### CABINET MEMBER FOR HIGHWAYS MANAGEMENT – 24 MARCH 2022

#### KENNINGTON: POPLAR GROVE – PROPOSED AMENDMENT OF WAITING RESTRICTIONS

Report by Corporate Director, Environment and Place

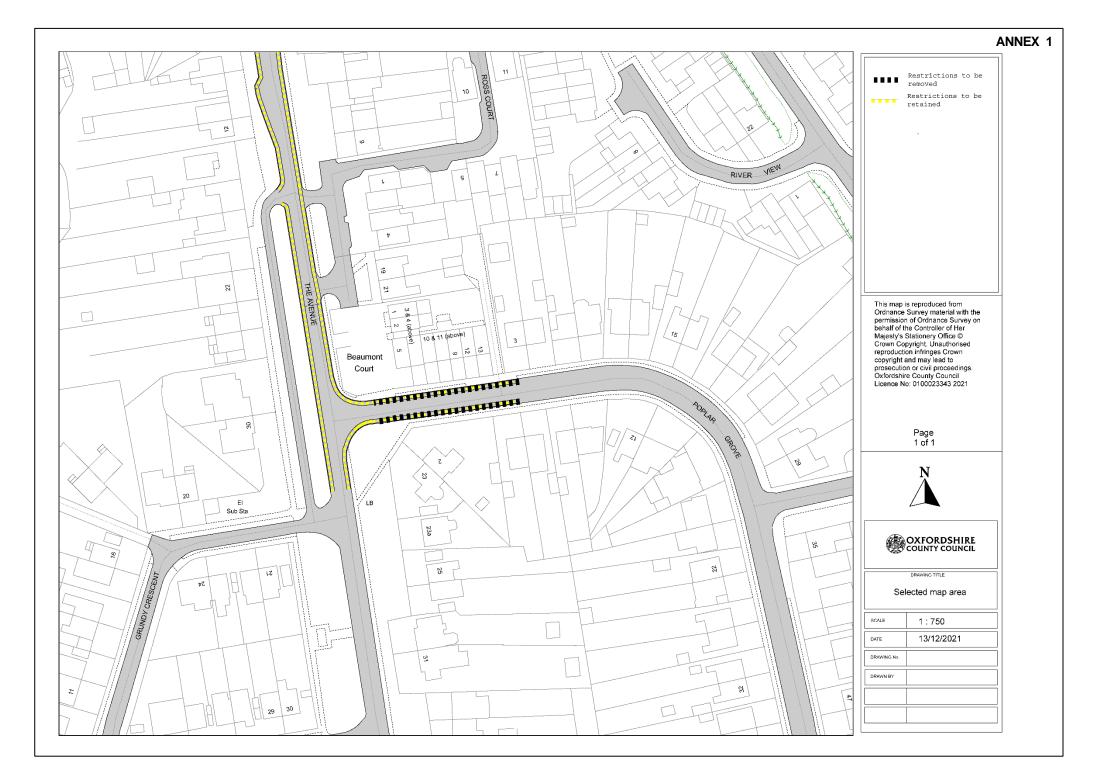
(3) Oxford Bus Company	<b>Object</b> – This is a concern: Our 35A school bus has to use Poplar Grove (morning and afternoon) in order to cover the Kennington route and turn from Manor Grove to come back through the village on The Avenue. This is some distance from the school and I'm not sure whether parking for the school is really relevant (if it was just that it would be less of a problem for us as we use the road at approx. 08:00 and 15:45 - a little outside the busy times for primary schools). There has however been recent development in the area and there is likely to be pressure to find places to park, for residents etc. Removing the double yellow restriction 'on both sides' is likely to cause issues for our 35A service (maybe worse in the morning) and I think this needs to be re-considered. We only use Poplar Grove in one direction - southbound/clockwise and I would recommend that, if parking restrictions here have to be changed, that the yellow lines are removed on one side only (removed on the south side only so that our carriageway is kept clear). If parking on both sides is allowed on a fairly narrow road it may be difficult for the bus to get through - and the 35A has no alternative route available. We therefore OBJECT to this proposal as it currently stands.

(4) Oxford Bus Company, (Service Delivery Department)	<b>Concerns</b> – We currently operate the 35A school services in the morning and afternoon which turn from The Avenue into Poplar Grove. My concern is that by removing the double yellow lines, it will make it difficult for large double decker vehicles to make the turn.

1. The Cabinet Member for the Highway Management is RECOMMENDED to approve the proposed amended waiting restrictions at Poplar Grove Kennington on the south side of the road only, but with no changes to be made to the existing restrictions on the north side of the road so as to ensure the passage of buses using the road.
